Airworthiness Directives; Eurocopter France Model SA-365C, C1, C2, N, and N1; AS-365N2 and N3; and SA-366G1 Helicopters

ACTION: Notice of proposed rulemaking (NPRM).

Eurocopter France: Docket No. 99-SW-62-AD. Supersedes AD 99-21-24, Docket 98-SW-75-AD, Amendment 39-11369.

Figure 1

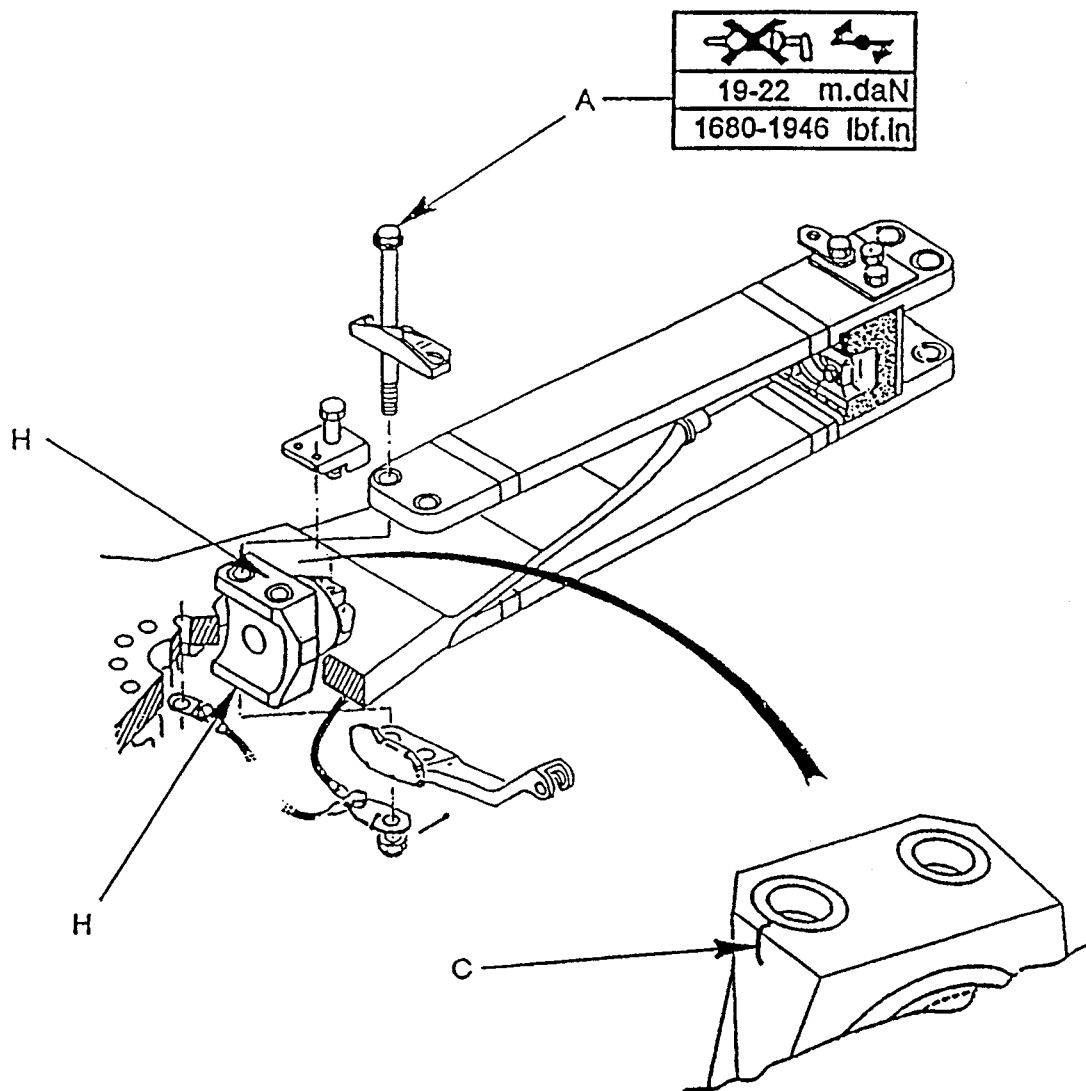
(a) Inspect the tightening torque of the bolts as indicated by "A" in Figure 1.

(1) If tightening torque is equal to or less than 12 m.daN (88.4 lb-ft), remove the bearing and conduct a dye penetrant inspection for cracks on the two contact surfaces identified as "H" in Figure 1.

(i) If a crack is detected, replace the bearing with an airworthy bearing.

(ii) If no crack is detected, reinstall the bearing.

(2) If the tightening torque is greater than 12 m.daN (88.4 lb-ft), then tighten the torque to 19-22 m.daN (140-162.2 lb-ft).
